Application No. 10/797,447  
Response dated April 19, 2005  
Reply to Office Action of January 19, 2005

**AMENDMENTS TO THE DRAWINGS**

**REMARKS**

FIG. 2

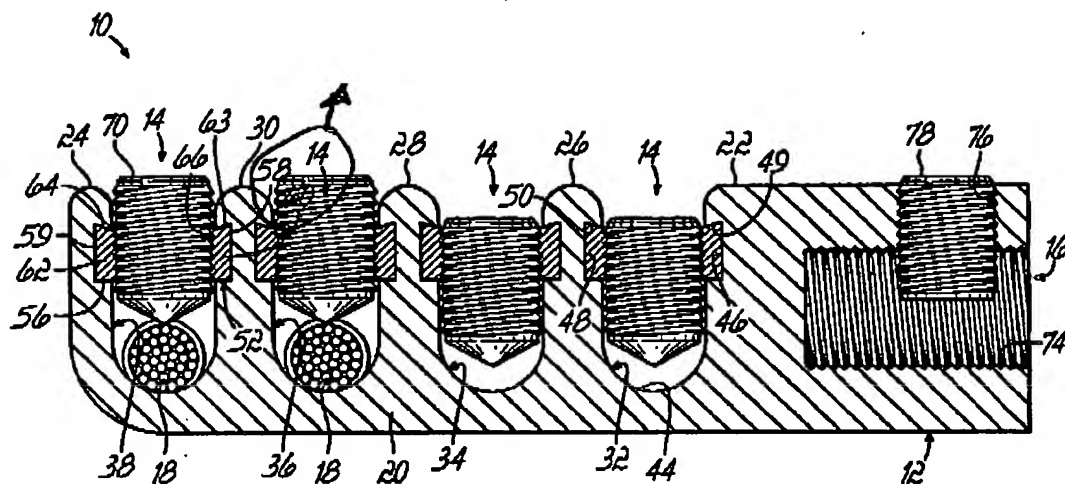
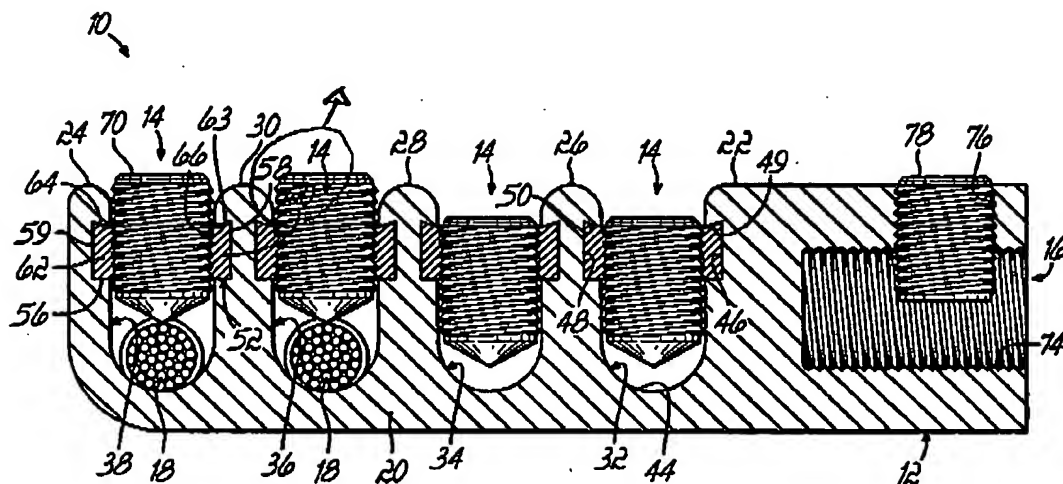
Applicants submit herewith proposed drawing changes to add Figs. 2A-2B and to correct a number of typographical errors in the previous drawings. In particular, the Examiner objected to the drawings for failing to show claimed features recited in claims 6-8 and 19. Figs. 2A-2B show these features more clearly. Moreover, a number of reference numerals (e.g. 14, 60) in Fig. 2 are within the drawing and therefore difficult to see. The reference numerals have been moved outside the drawing. Additionally, the binding screw 78 and threaded opening 76 associated with bore 16 were improperly labeled in Fig. 3. These reference numerals have been changed to correspond to the correct reference numerals used in the specification. The Examiner is respectfully requested to approve these proposed drawing changes. No new matter is being introduced by the revised drawings.

In the Office Action, the drawings were objected to under 37 C.F.R. § 1.83(a) as failing to show every feature of the invention specified in the claims. In particular, the Office Action asserts that the features of claims 6-8 and 19 are unclear as they are not shown in the drawings. Applicants have added new Figs. 2A-2B and amended the description to conform the drawing and specification to the original disclosure in the claims. The drawings have also been amended to correct certain typographical errors. Applicants submit that no new matter is being added by the additional drawings, amendments to the drawings and amendments to the specification. The Examiner is therefore respectfully requested to approve these additional and revised drawings and withdraw the objection.
